**ZONING AMENDMENT,  
PLANNED UNIT DEVELOPMENT &  
SUBDIVISION STAFF REPORT**

**Date: January 20, 2011**

Overlook Road VOA Housing Subdivision

6917 Overlook Road  
(South side of Overlook Road, 625'± East of Cody Road)

# SITE PLAN

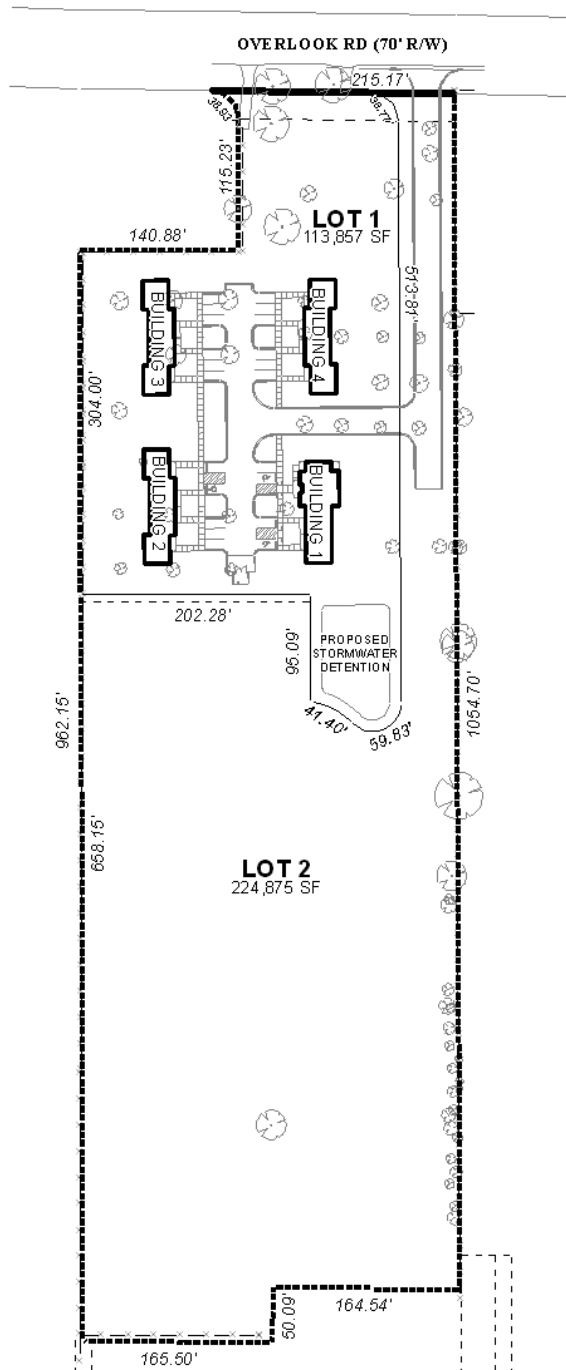
The proposed lots are of sufficient size and have sufficient public right-of-way frontage to be compliant with the requirements of the Subdivision Regulations. The lot area sizes are depicted on the plat in square feet; this should be revised to also include acres.

The 25-foot minimum building setback is depicted along the entire Overlook Road frontage for both lots. This should be revised to be along Overlook Road for Lot 1 only. The 25' minimum building setback line for Lot 2 should be depicted as measured from the Southern boundary of Lot 1.

*Although the site plan indicates compliance with required building setbacks, parking and site coverage, no landscaping calculations are indicated and tree plantings which are indicated are insufficient for the site. Also, the lot configuration on the landscaping site plan for the proposed development does not agree with the lot configuration for Lot 1 of the proposed subdivision in that the detention area is not included, but some of the proposed Lot 2 is included. Therefore, an accurate review cannot be done for the site.*
